# Service Bulletin N° 91

**SUBJ:** *TWISTER* Magnet Processor Board & Magnet Disc Motor Updates

## **BOARD UPDATE PROCEDURE:**

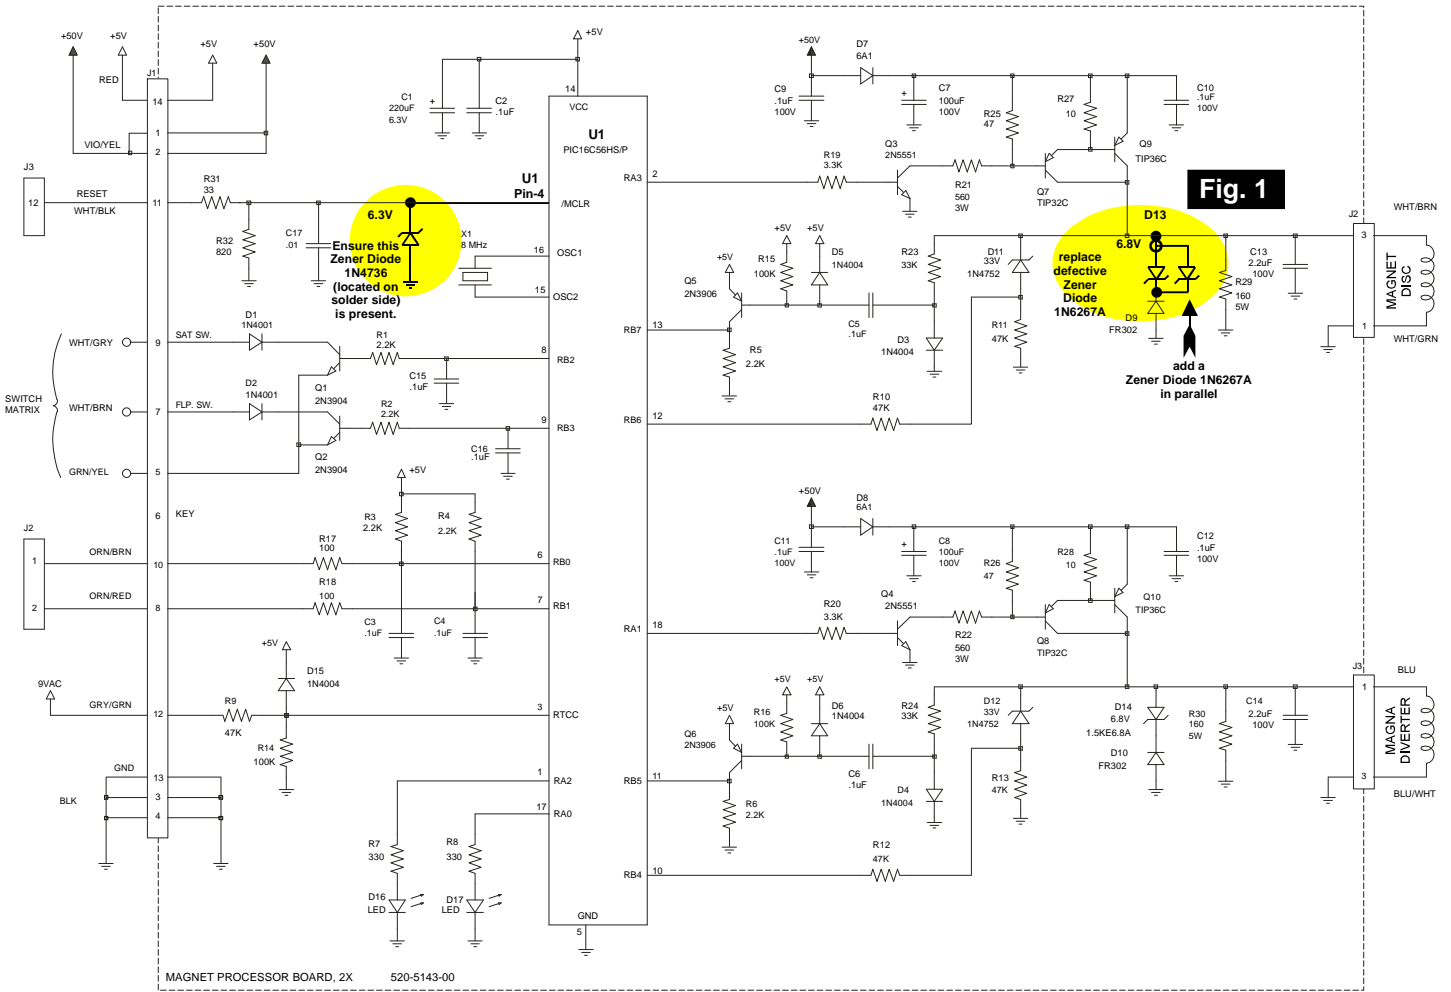
Replace the defective Zener Diode 1N6267A, Sega Part N° 112-5011-00, and add one in parallel at Loc. D13; Ref. Fig. 1 on the Magnet Processor / Driver Schematic *on the next page*.

# MAGNET PROCESSOR SCHEMATIC

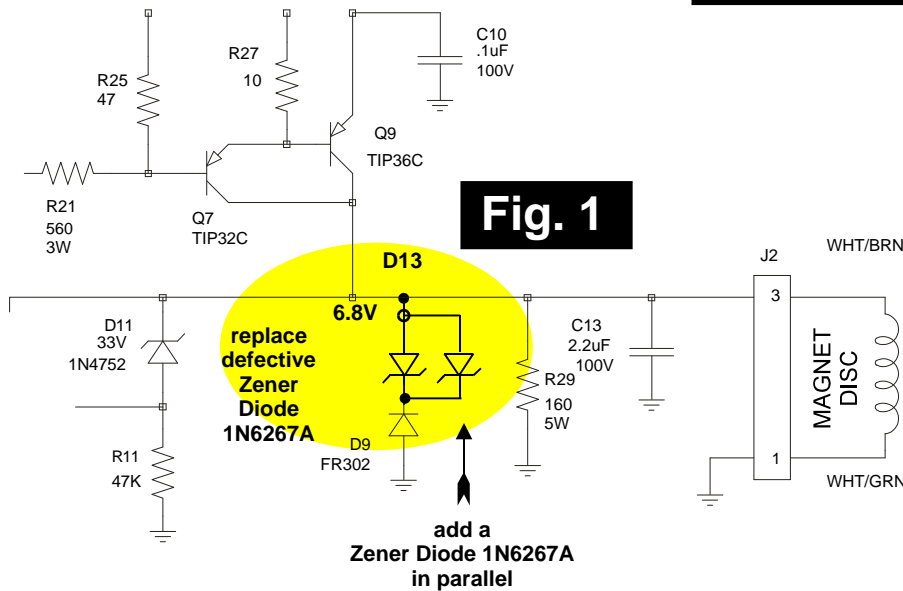
**Please Note: Update your Manual Schematic, Section 5, Chapter 2, Page 90: As shown above, J2 should be Magnet Disc, and J3 should be Magnet Diverter. The manual referenced them the other way around.**

# MAGNET DISC MOTOR DRAWING

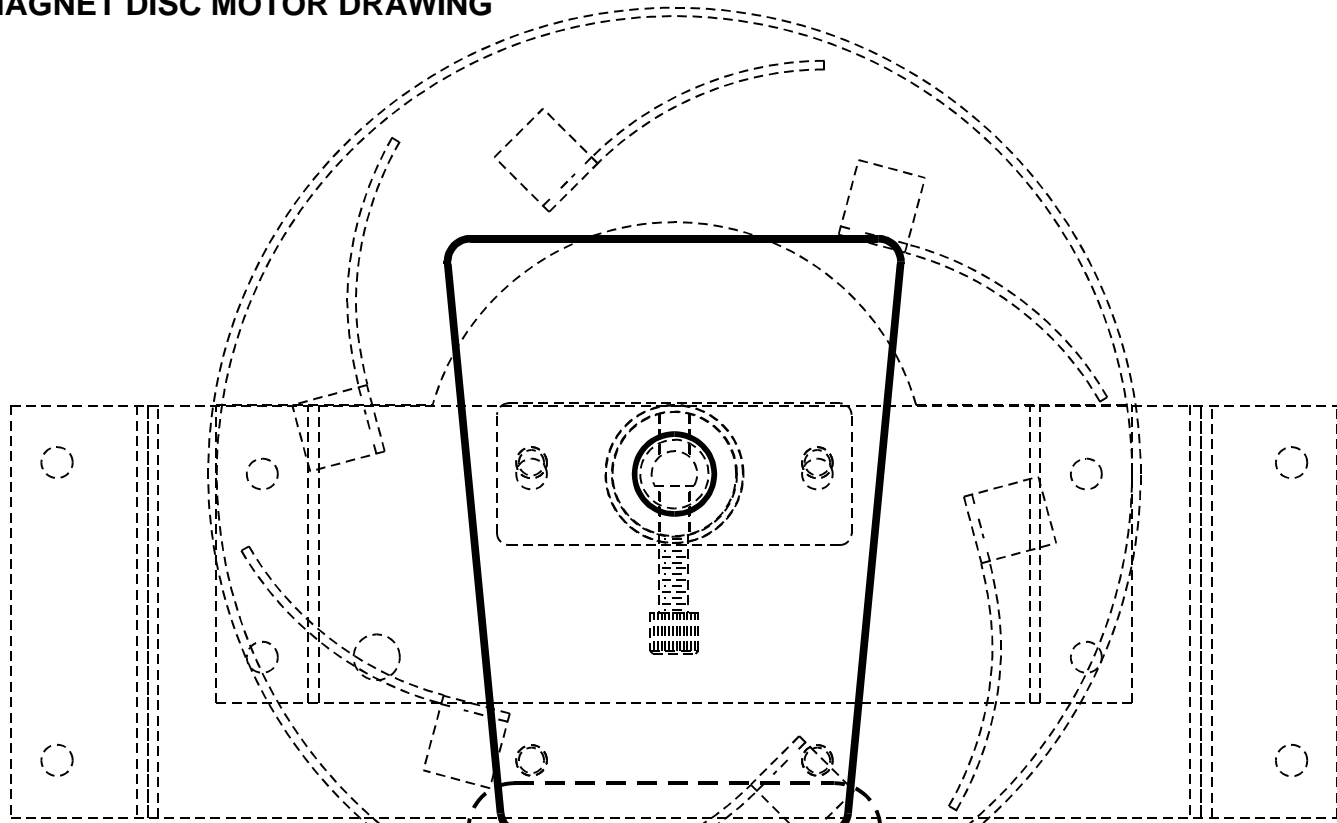
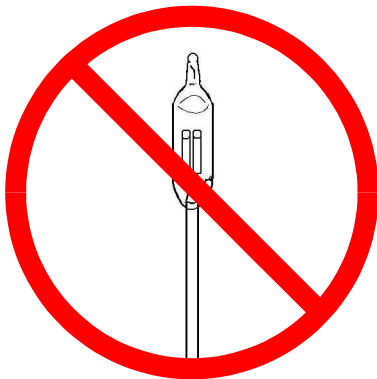
Remove the Neon Bulb  
from the Magnet Disc Motor  
Connector by clipping the leads.

This connector should have  
this large yellow capacitor, not the  
small "disc" shape .01 Capacitor.

After removal of the Neon Bulb, add  
this resistor in series with the Capacitor.
